- 3. Granross Grove 2022 Replat; KPB File 2022-134
Mullikin Surveys / Baumgardner
Location: Ester Avenue & Granross Street
Anchor Area / Anchor Point APC**

ITEM 3 - GRANROSS GROVE 2022 REPLAT

KPB File No.	2022-134
Plat Committee Meeting:	September 26, 2022
Applicant / Owner:	Kent Baumgardner of Anchor Point AK
Surveyor:	Christopher Mullikin / Mullikin Surveys
General Location:	Ester Avenue, Anchor Point / Anchor Point APC

STAFF REPORT

PRELIMINARY PLAT

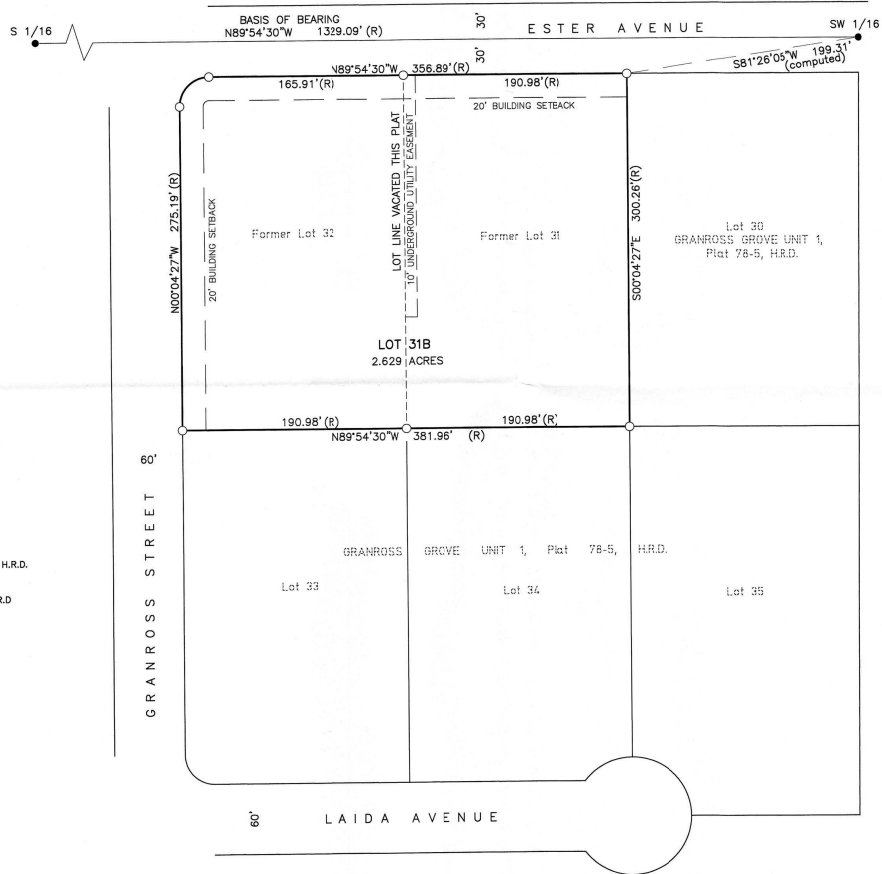
Site Investigation: There are no wetlands or steep areas present. The terrain slopes to the southwest corner from the north at a 6 percent grade overall. The plat is not in a flood hazard area. Plat note 6 references a map panel for flooding. The property is within the bounds of that panel but the property itself is not within a flood hazard zone. This was confirmed by the staff review at the River Center. **Staff recommends plat note 6 be removed per the response from the River Center.**

There are several existing structures located on the property. KPB GIS parcel line data and KPB GIS imagery are not exact. Structures found in Lot 32 appear to be very close to the property lines. While a field survey is not required staff would recommend the surveyor verify the locations of the buildings in regards to the property lines, utility easements, and building setbacks. The structure on Lot 31 should be verified that it is not within the 10 foot utility easements. This platting action is not creating lines to create encroachments but encroachments may exist. If there are structures within the dedicated rights-of-way, a resolution should be put into place prior to finalizing the plat. If the structures are within the existing utility easement or existing building setbacks, it is recommended that the issues be resolved as they may create issues for the owners in the future. Any encroachments into the right-of-way or setback will be provided to the Roads Department and KPB Code Compliance Officer. This plat will be required to grant new 10 foot utility easements along the rights-of-way. If any of the structures are within the new easement they may be exempt if the structures are shown and appropriate plat notes are added. This will still not

resolve any setback encroachments. **Staff recommends** the location of buildings be located and the status of any encroachments be staff with possible methods of resolution. If no encroachments are found this should be submitted in writing to Platting Staff.

- *The Mullikin Surveys label above the title block is not required as the information is in the title block. If trying to include company logo, it can be incorporated into the title block or may remain.*
- *The line symbol for neighboring lot lines should be added to the legend.*
- *The legend states the one line symbol is for easement lines not surveyed but appears to be the former lot line.*
- *Add curve data to the curve in the northwest corner of Lot 31B.*

Staff recommendation: Remove the second line in the title: "A Lot line vacation Plat". Add KPB file number to title block 2022-134.

Staff recommendation: Add labels for land to the west across Granross Street and north of Ester Avenue. Change the font of the labels as reproduction could lose text. The depiction of neighboring properties only is required to 100 feet. The depiction of Laida Avenue is not required but may remain.

Staff recommendation: Surveyor should check the structures on parent Lot 32 for location to property lines and setbacks. If found to be an issue, show on drawing and add the following statement: "Acceptance of this plat by the Kenai Peninsula Borough does not indicate acceptance of any encroachments." Issues may be dealt with prior to final approval.

Plat note 6 may be removed.

Plat note 1 needs a correction to the lot number being created.

Plat note 2, please add the reference to KPB Code that allows for no field survey. "No field survey was conducted as provided in KPB Code 20.60.200(A)."

Staff recommendation: The certificate of ownership needs to be revised as it currently states right-of-way acquisition instead of subdivision. Update the year in the Notary's Acknowledgment. The plat approval note should comply with 20.60.190(C). Comply with 20.60.190.
